Access Compliance Report

Public Rights-of-Way

(Curb Ramps)

Intersection ID: 10036927	Main Street: S_SHARON_AMITY_RD	Cross Street: N/A	Location: NE
ADA ID: E72FC7C28278	Ramp Type: PerpDiag	Initial Pass/Fail: Fail	Overall Compliance: No
Severity Score: 25			
Codes/Mitigation Info/Possible Solution		Field Measurements/Component Compliance

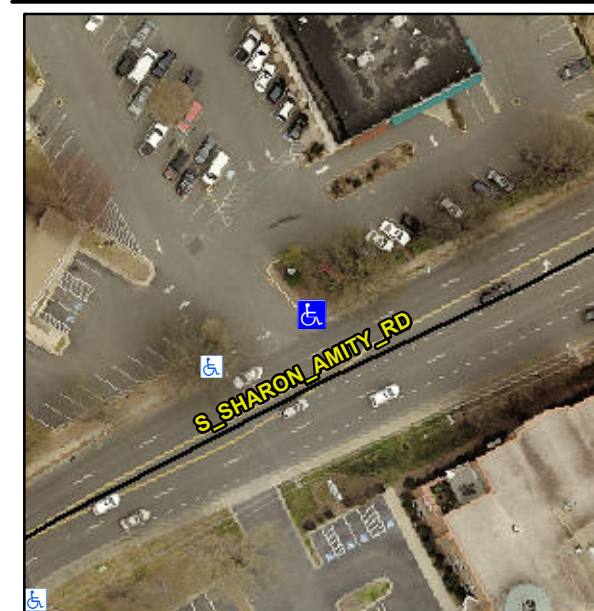
Not Found, R304.2.2

Compliance	Description	Data	Compliance	Description	Data
N/A	Ramp Length (in)	54.0	No	Ramp Slope (%)	12.3
Yes	Ramp Width (in)	67.0	Yes	Ramp XSlope (%)	1.2
N/A	Flare Type LT	N/A	N/A	Flare Type RT	N/A
N/A	Flare Slope LT (%)	N/A	N/A	Flare Slope RT (%)	N/A
N/A	Flare Traversable LT?	N/A	N/A	Flare Traversable RT?	N/A
N/A	Landing Length (in)	N/A	N/A	DWS Provided?	N/A
N/A	Landing Width (in)	N/A	N/A	DWS Contrast?	N/A
N/A	Landing Slope (%)	N/A	N/A	DWS Length (in)	N/A
N/A	Landing X Slope (%)	N/A	N/A	DWS Full Width?	N/A
N/A	Landing Curb? (Y/N)	N/A	N/A	DWS Offset (in)	N/A
N/A	Shared Landing?	N/A			
N/A	Gutter Ponding?	N/A	N/A	Gutter Slope (%)	N/A
N/A	Gutter Lip Ht (in)	N/A	N/A	Gutter X Slope (%)	N/A
N/A	Painted X Walk1?	No	N/A	Painted X Walk2?	No
	X Walk 1 Direction	To SW		X Walk 2 Direction	To SE
N/A	X Walk 1 Width (in)	N/A	N/A	X Walk 2 Width (in)	N/A
	X Walk 1 Slope (%)	0.6		X Walk 2 Slope (%)	0.9
	X Walk 1 X Slope (%)	0.8		X Walk 2 X Slope (%)	1.6

Remove & Replace Curb Ramp With Two New Directional Ramps or Equivalent.
